Plane View @ "B"
SCALE: NONE
(DEPICTING FEATURES AT VARIOUS LEVELS)

SPRINGER'S JEWELRY
FALMOUTH, ME

CONTRACT No. 18729
SHEET No. 2 OF 4

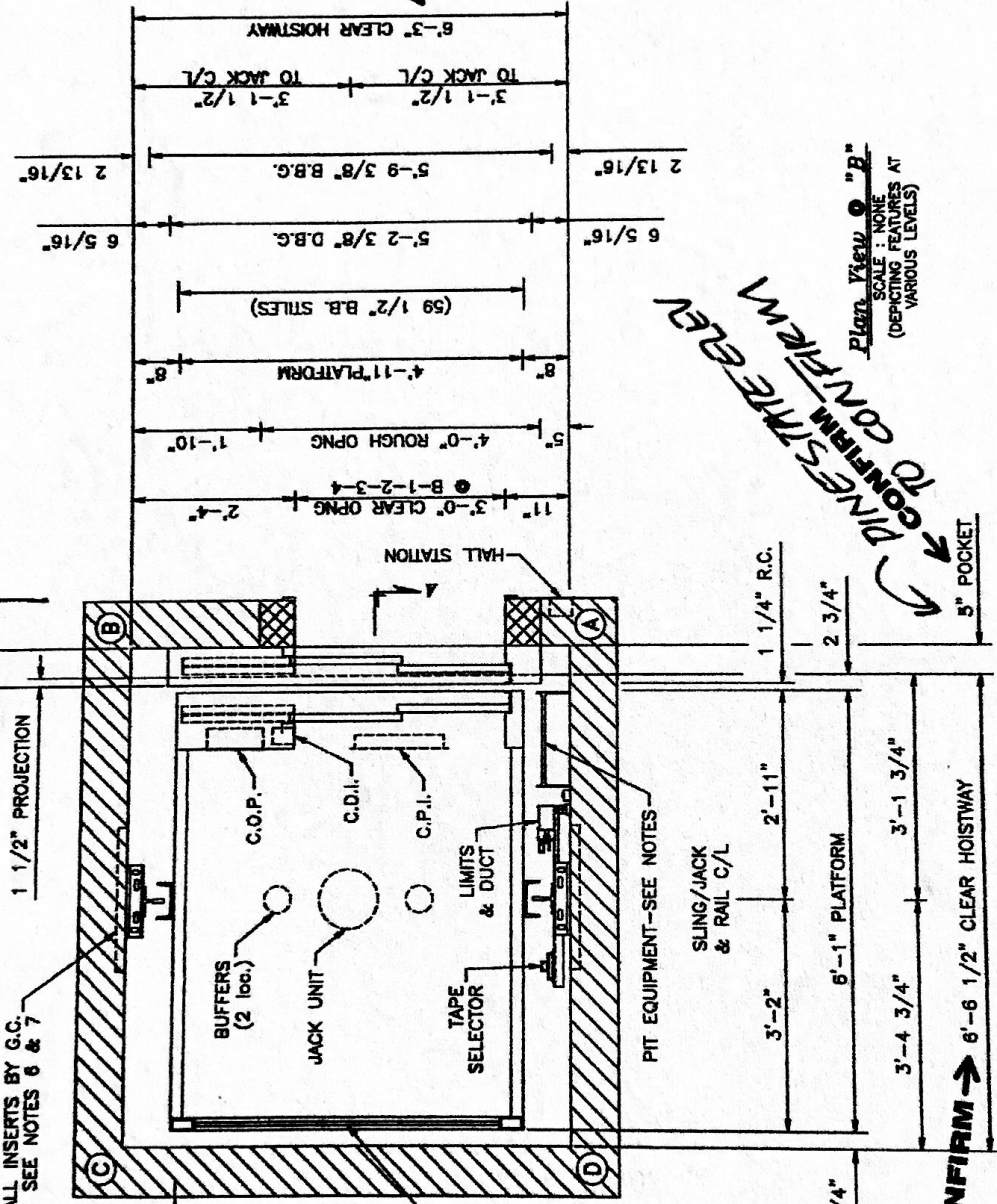
6'-4" @ PIT
THIS IS THE TIGHTEST DIMENSION OF SHAFT

CONFIRM → 6'-6 1/2" CLEAR HOISTWAY

5'-9 1/2" @ PIT
THIS IS THE TIGHTEST DIMENSION OF SHAFT

REVIEWED 4-7-17
miam e. duffin RA
